Strategic Housing Development

St. Teresa's, Temple Hill, Monkstown, Blackrock, Co. Dublin

Response to ABP Opinion and DLRCC Opinion
1706A-OMP-ZZ-ZZ-SA-A-008
December 2021

This document is prepared by O'Mahony Pike Architects in response to the Opinion issued by An Bord Pleanála to the applicant Oval Target Ltd on 21st June 2021, following the tri-partite meeting of 30th April 2021.

SECTION E-E

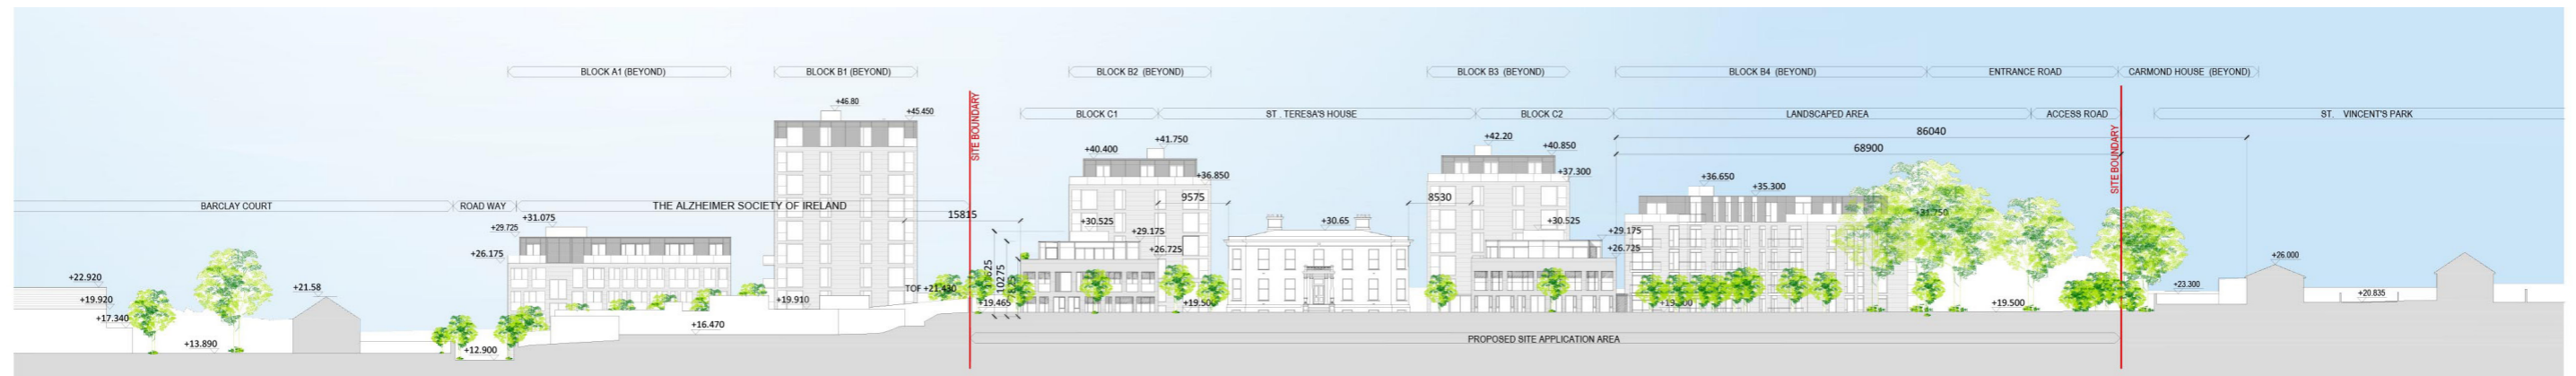
“Further consideration and/or justification of the documents as they relate to the design strategy for the site in respect of: (a) The interface with The Alzheimer Society, interface with Temple Hill Road, interface with Rockfield Park and interface with St. Teresa’s House as they relate to the design, scale and layout of the proposed development and the desire to ensure that the proposal provides a high quality, positive intervention at this location. This should include a contextual layout plan which indicates the layout of adjoining developments, photomontages and cross sections at appropriate levels.”

Existing brick site boundary wall retained.

Opaque glazed privacy screen on top of parapet wall, up to height of 1800 mm above FFL of Block C1 roof terrace.

SECTION C-C

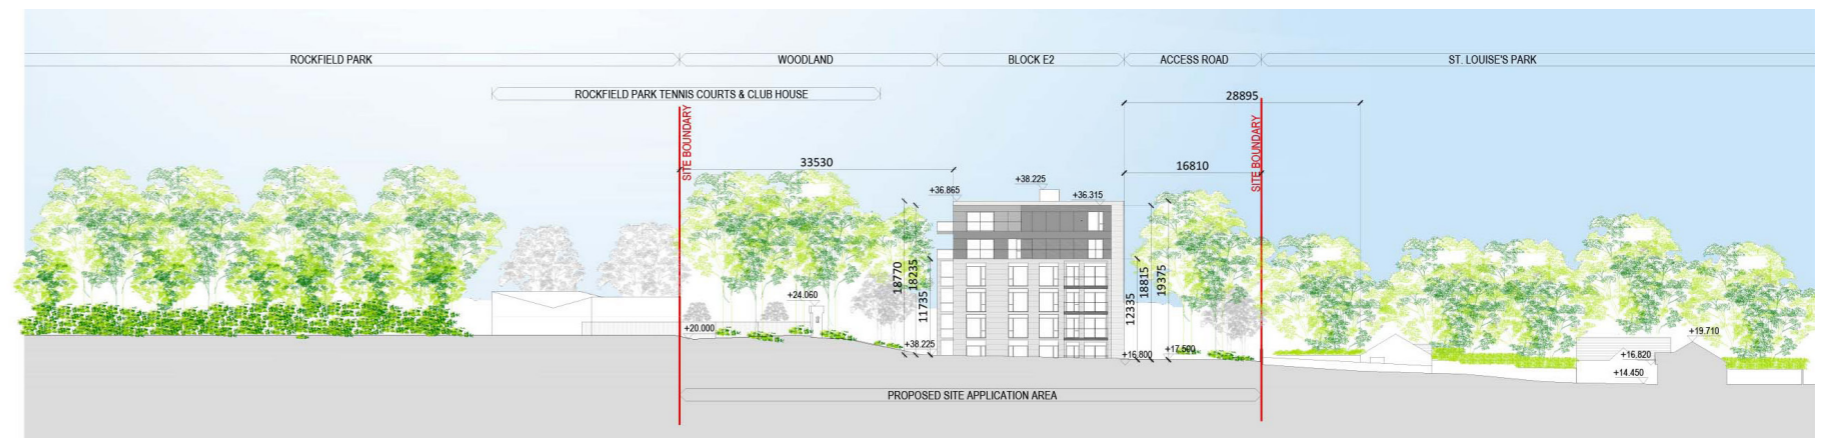
7. The current proposal provides for the removal of the existing boundary wall to Rockfield Park which will allow for connectivity and permeability through the site providing a beneficial link to the adjacent park. Objective DS6 requires the provision of an appropriate low boundary treatment to be erected between the tree belts and any proposed residential development within the St Teresa's and Dunardagh landholding. The extant planning permission included a boundary railing with a height of c. 1.2m between the woodland park and Blocks E1-E5 which acted as the informal boundary between Rockfield Park and the proposed scheme. The Applicant should therefore modify the proposal to reinstate the parkland railing in accordance with the extant permission.

Proposed new parkland railing c. 1.2 m high.

Line of existing stone boundary wall, to be removed

Ground Floor plan - BLOCK E2 - showing no residential development on Zoning Objective 'F' lands.

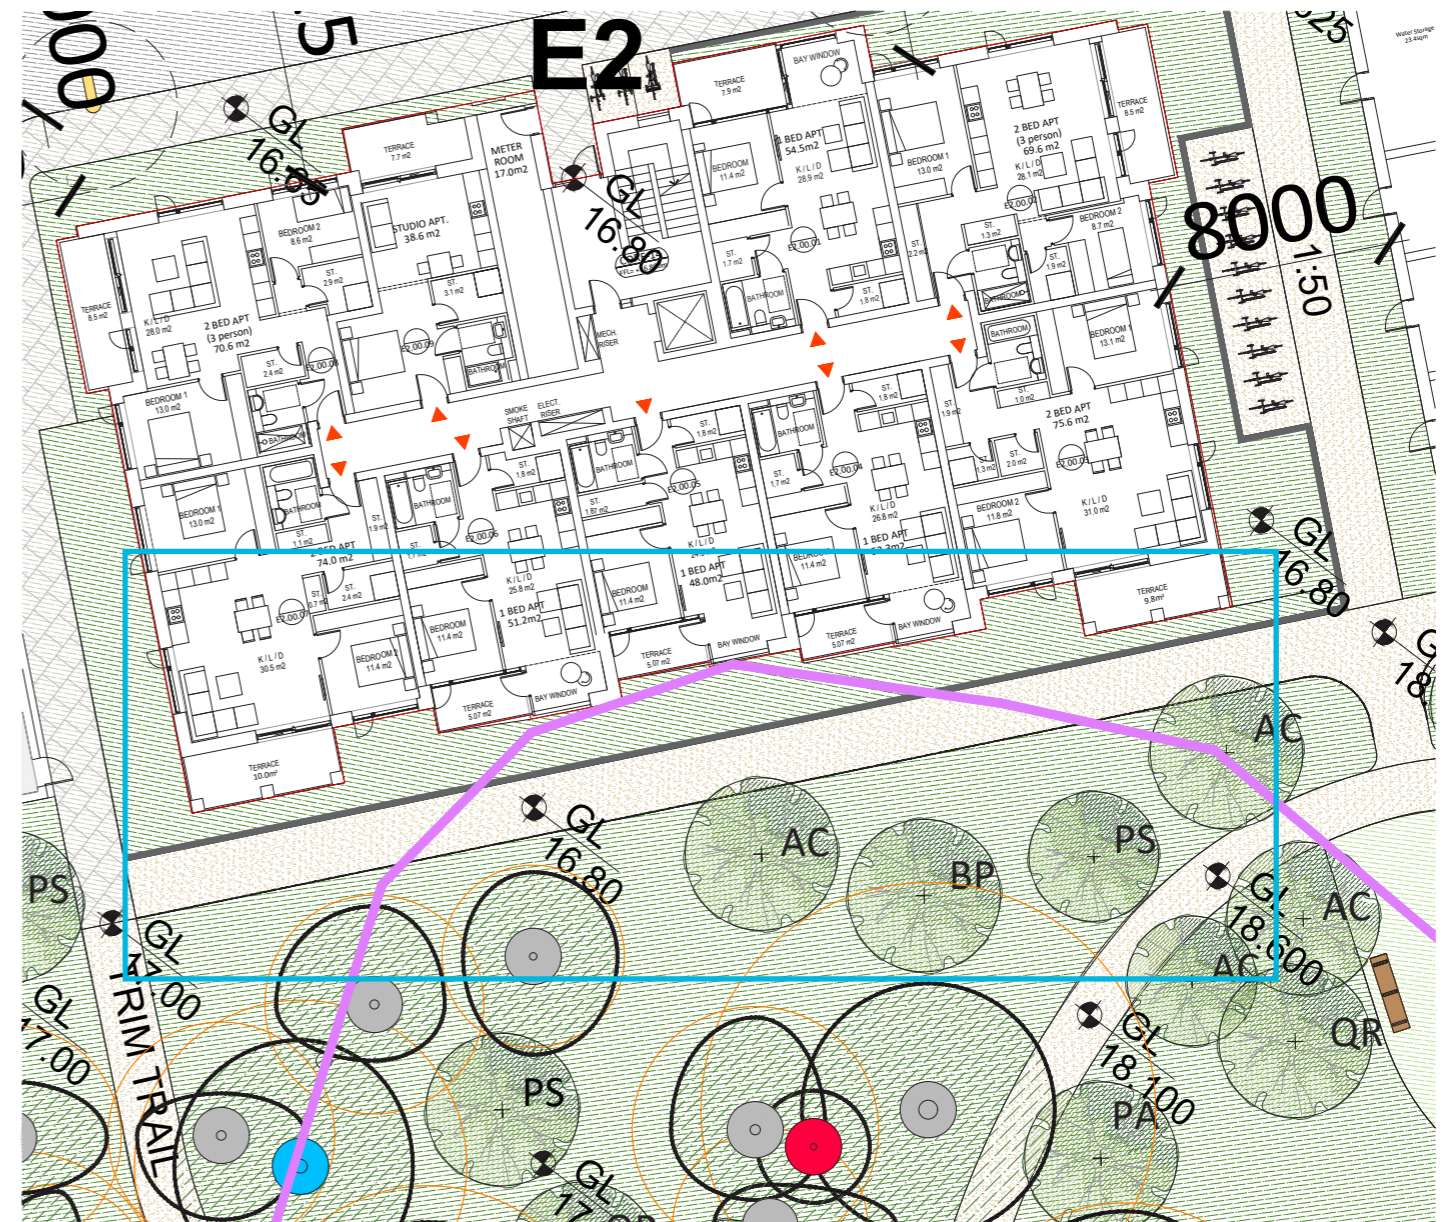
- From a review of the submitted documentation, it would appear that the modified Block E2 now encroaches on land which is zoned Objective 'F'. It is noted that a residential use is contrary to zoning Objective 'F' and the Applicant is therefore requested to submit revised proposals which demonstrates that all residential development is located on zoning Objective 'A' lands.

Part of the private amenity space (balconies) of three of the apartments on the south-east elevation of Block E2 encroached into the Zoning Objective 'F' lands. The area of private amenity space (balconies) that was within the 'F' zoning area was 10.37 m².

The floor plans of Block E2 have been modified so that none of the balconies encroach into the 'F' zoned lands. All residential development is therefore located on Zoning Objective 'A' lands.

Block A1 - Proposed modification to penthouse level - 4th floor.

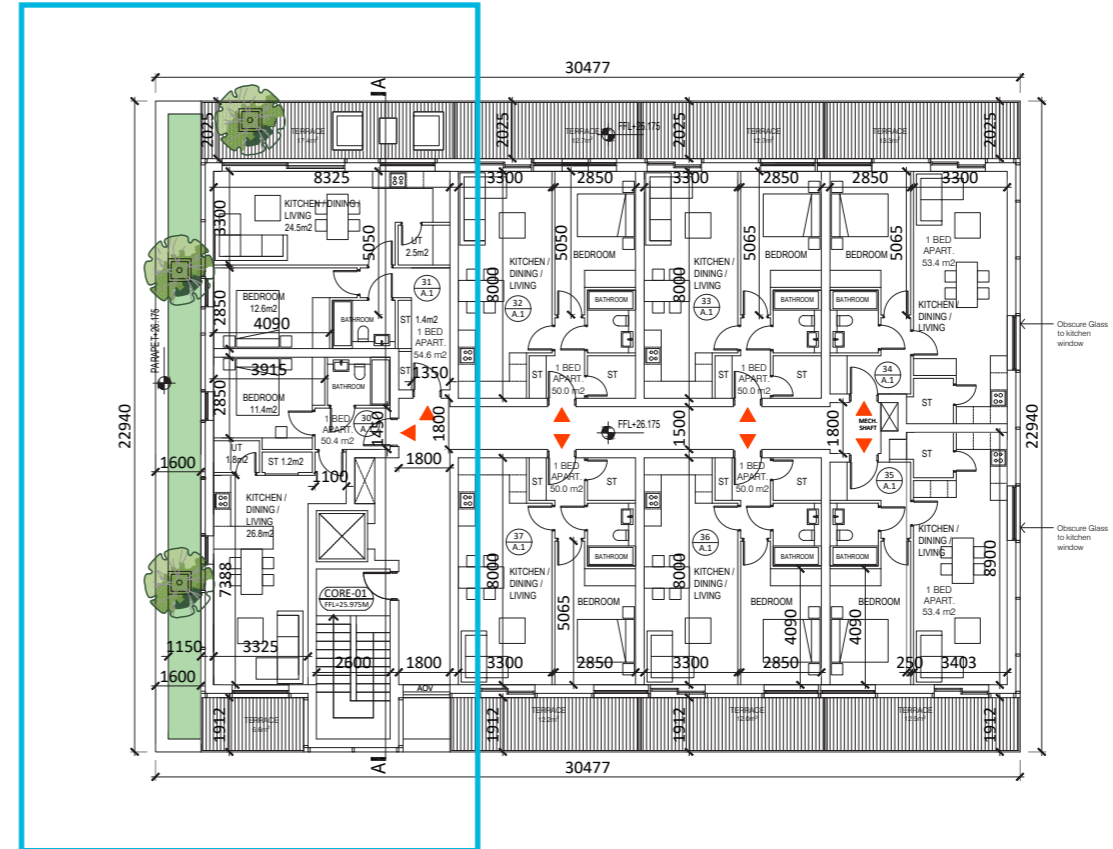
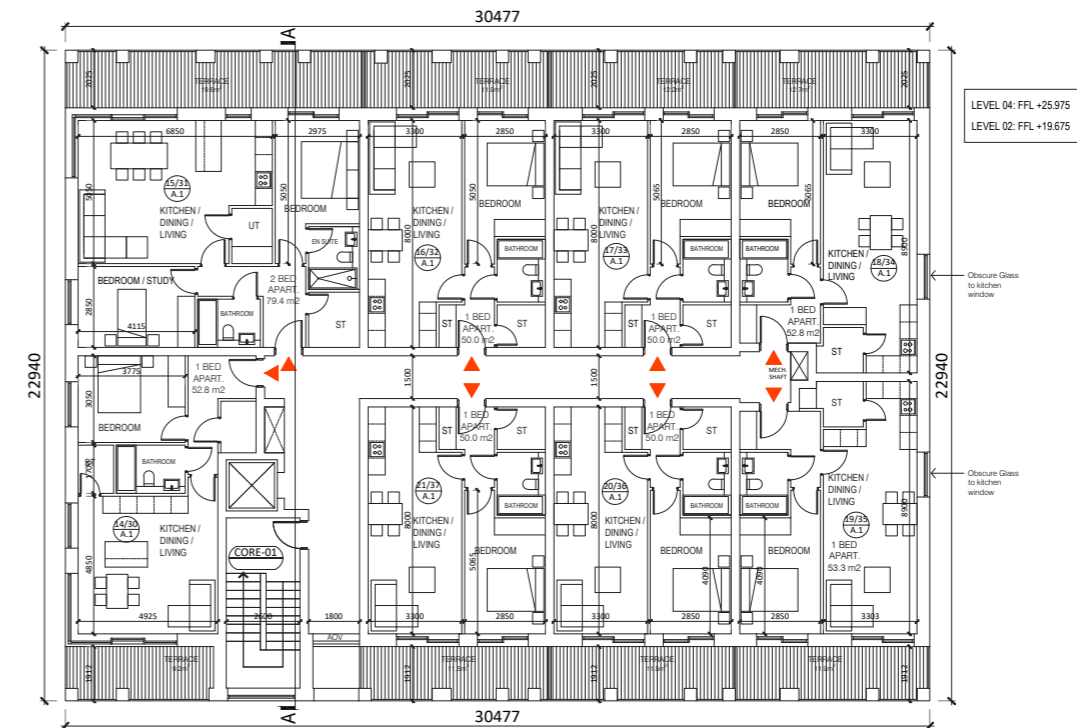
3. The Planning Authority has significant concerns regarding the increase in height and the modification to the design of a number of apartment blocks within the proposed development. The proposal has the potential to severely compromise the residential amenity of properties within the surrounds and is considered to be contrary to the objectives and design principles of the Blackrock LAP. A detailed analysis of each apartment block within the scheme has been included within the foregoing report.

Following the Tri-partite meeting and the issue of the DLR and ABP opinions, we have modified Block A1 to include a set back penthouse at 4th floor level similar to the set back penthouse level of the previously permitted development. The result of this modification is that the building volume and massing is reduced and the architectural treatment of the top floor level is perceived to be of a lighter construction and with a more visually interesting surface appearance and roof profile. The footprint of the top floor is reduced and the height of the parapet is also reduced.

Set back penthouse at 4th floor replaces full typical floor plan.

Volume and massing are reduced. Roof profile and parapet height reduced.

Block B4 - Proposed typical floor plan with outline of previously proposed building shown in red.

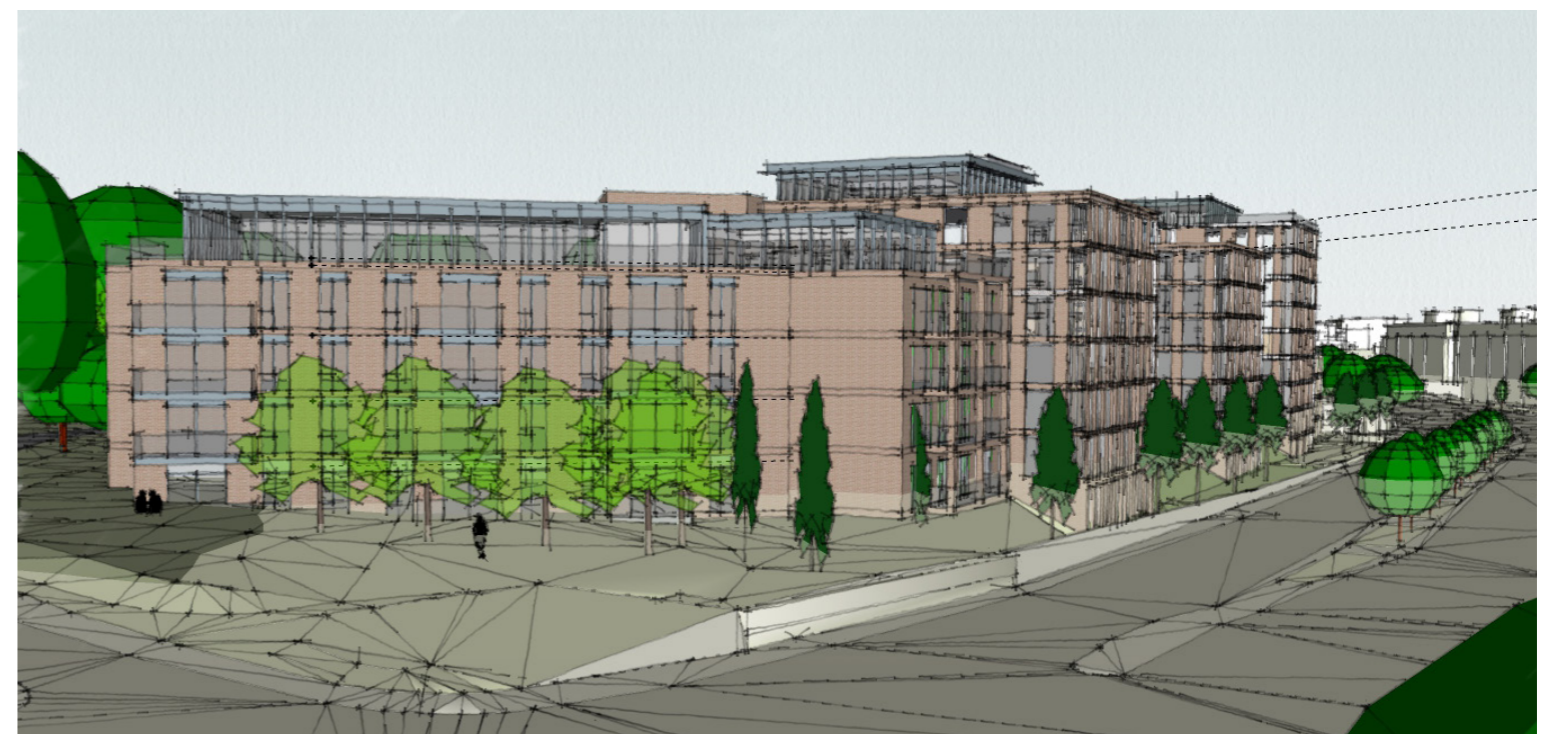
5. The design and configuration of Blocks A1-B4 has not adopted a non-orthogonal approach to Temple Hill Road as envisaged in the Site Framework Strategy. Although it is acknowledged in the Blackrock LAP that the layout and guidance contained within the Site Framework Strategies should not be viewed as the only definitive development solution for the sites in question, the Planning Authority has significant concerns regarding the form, massing and scale of Block B4. The current scheme represents a significant departure from what was previously permitted, and the overall visual impact of the proposal is compounded by the loss of previously proposed landscaping within the north-eastern portion of the site.

- The separation distance of Block B4 from the existing houses on the opposite side of Temple Hill Road is c. 44m which is appropriate . The reduced footprint and set back at penthouse level will improve the appearance of this building and lessen its visual impact

ITEM 9: DESIGN RESPONSE

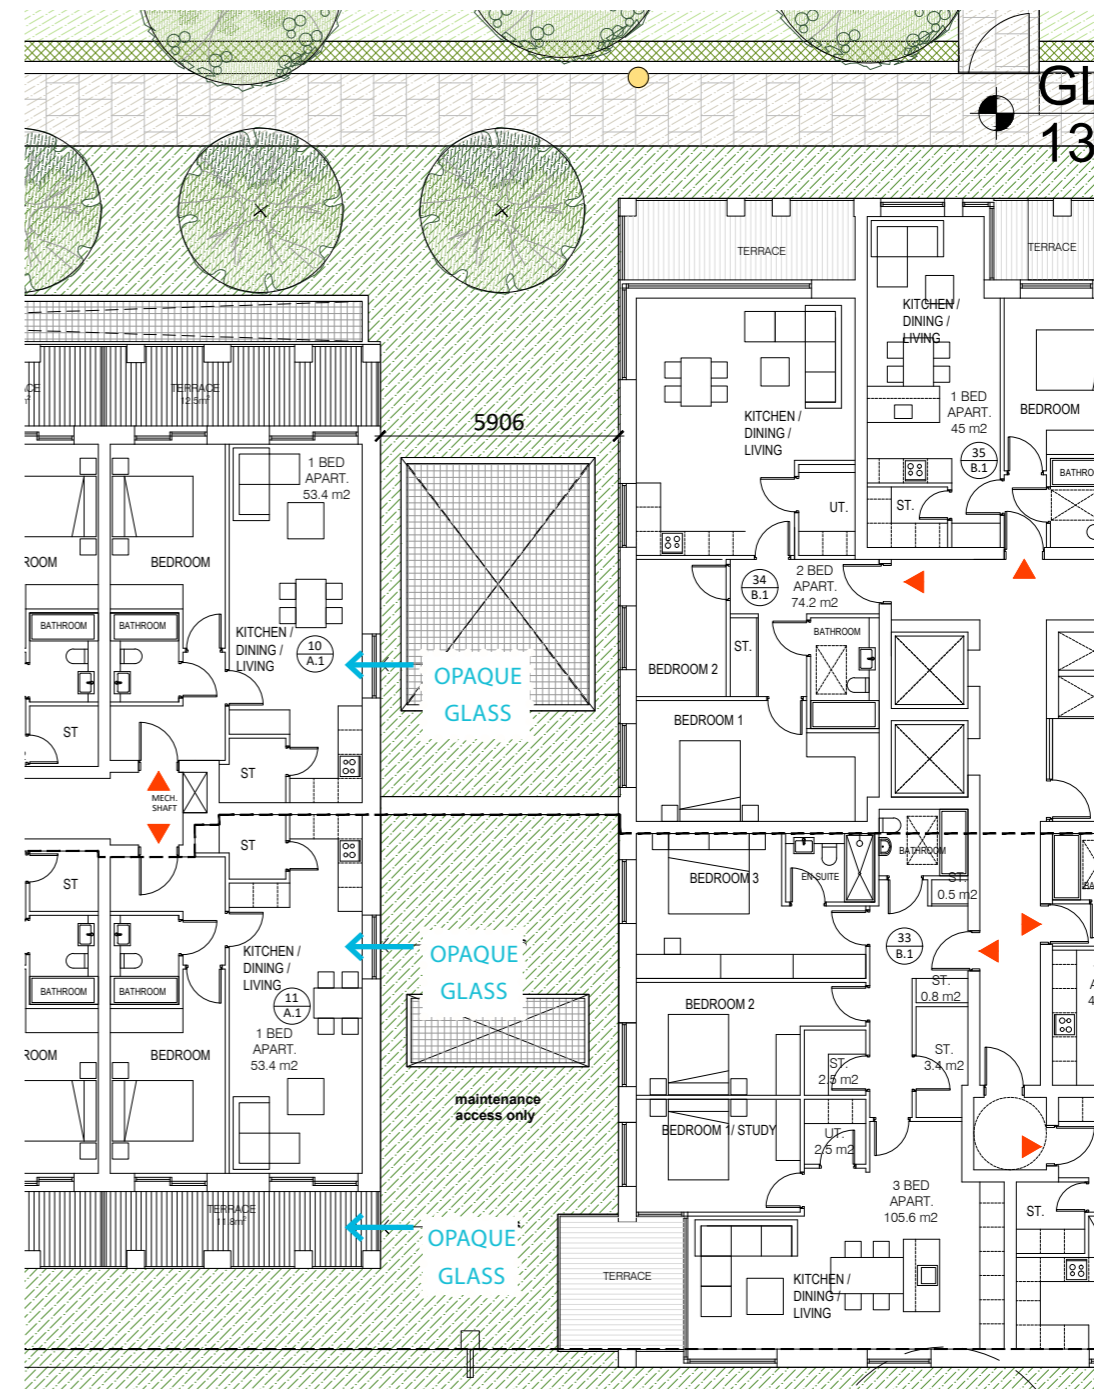
9. The Planning Authority has significant concerns regarding the separation distances between a number of blocks within the scheme. This is particularly relevant in the context of the separation distances between Block B3 and B4, Block A1 and B1 and Block E1 and E2, whereby the buildings are separated by distances of between c. 6m to 8m. This is an unacceptable arrangement, particularly in instances where balconies within the blocks directly face habitable rooms (i.e. bedrooms and living rooms) within the directly opposing apartments. This will result in a substandard level of amenity for future occupants and will not be supported by the Planning Authority. Given the heights of the buildings and the minimal separation distances provided, the Planning Authority has also concerns that the rooms within the apartments of these blocks would not achieve the recommended Average Daylight Factor (ADF), particularly on the lower levels. A more detailed analysis should therefore be provided within the Daylight, Sunlight and Overshadowing Study.

- The separation distance between proposed Blocks A1 and B1 remains the same as in the permitted development at 5.9 m.
- The windows (2 no. per floor) in the south-east elevation of Block A1 are secondary windows to bring additional daylighting into the living / dining / kitchens of the end apartments and to provide improved ventilation. These windows are provided with opaque glass, so as to protect the amenity of the occupants of apartments in Block B1 opposite.
- The rooms in Block B1 located opposite the south-west gable of Block A1 are all provided with clear glass.
- This arrangement is as per the permitted scheme.
